FORM APPROVED
OMB NO 1004-0135
Expires July 31, 2010**SUNDRY NOTICES AND REPORTS ON WELLS**
*Do not use this form for proposals to drill or to re-enter an abandoned well. Use form 3160-3 (APD) for such proposals.***SUBMIT IN TRIPLICATE - Other instructions on reverse side.**

WELL NAME: Cerros AQF Federal Com #1 FIELD: Turkey Track
 LOCATION: 1,650' FSL & 990' FEL of Section 15-18S-29E Eddy Co., NM
 GL: 3,465' ZERO: KB:
 SPUD DATE: 11/22/96 COMPLETION DATE: 2/9/97
 COMMENTS: API No.: 30-015-29276

Cerros AQF Federal Com 1
Yates Petroleum Corporation
30-015-29276
24 April 2012
Conditions of Approval

Before

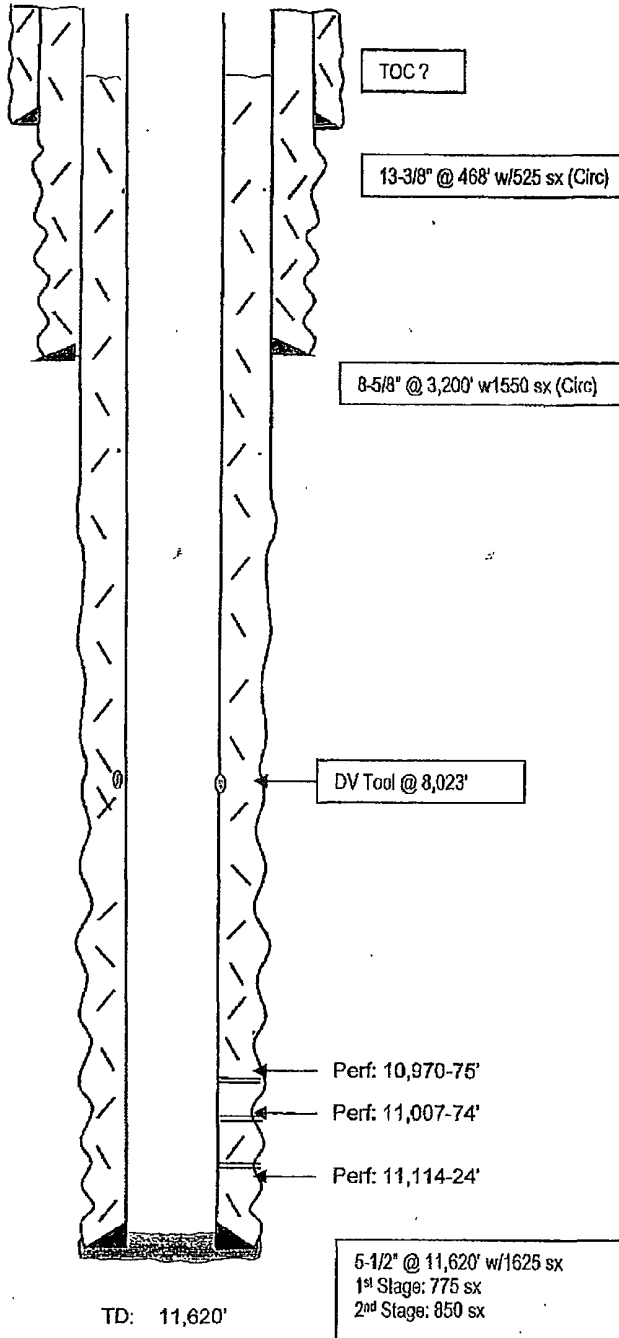
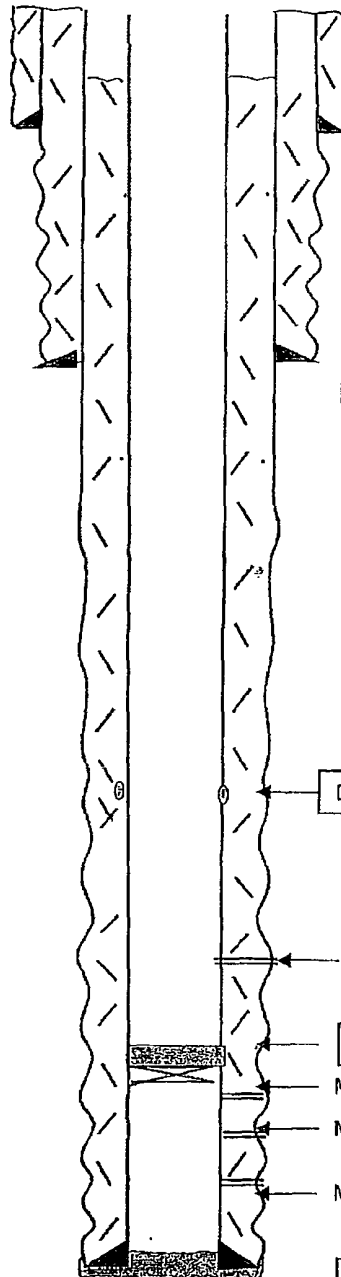
NOTE: Geological Review on 4/24/2012 indicates the revised actual formation tops are:

Abo Shale at 7470'
Wolfcamp at 8622' (always on the topside of the second shale peak)
Cisco at 9200' (the Cisco maybe 10 to 20 ft off, not sure)
Canyon at 9890'
Strawn at 10630'
Atoka at 11128'
Morrow at 11500'

- a. RIH with workstring and **tag PBTD at 11517'**. Cleanout fill if necessary. (PBTD is 17' below the re-evaluated top Morrow at 11500'.) BLM representative to be contacted for confirming cleanout depth prior to placing cement for plugback.

- b. Place 597' of cement on bottom, to permanently abandon the top Morrow formation at 11500' per BLM guidelines and to isolate the existing perforations from 10970' – 11124' selective. **New PBTD will be at 10920' or higher.**
NOTE: All cement plugs will be a minimum of 100 feet in length plus 10% for each 1000 feet or a minimum of 25 sacks, whichever is greater. If needed, the total cement volume pumped can be adjusted for a higher PBTD, to allow for the subsequent re-completion in the Wolfcamp.

- c. **Contact BLM to witness the tag of the new PBTD at 10920' or higher**, and for the pressure test of 5-1/2" 17# Production Casing in preparation for well recompletion. (Casing test pressure to consider availability and usage of a tree saver and a frac string with packer.) **500 psi** will be the minimum pressure test following BLM guidelines.
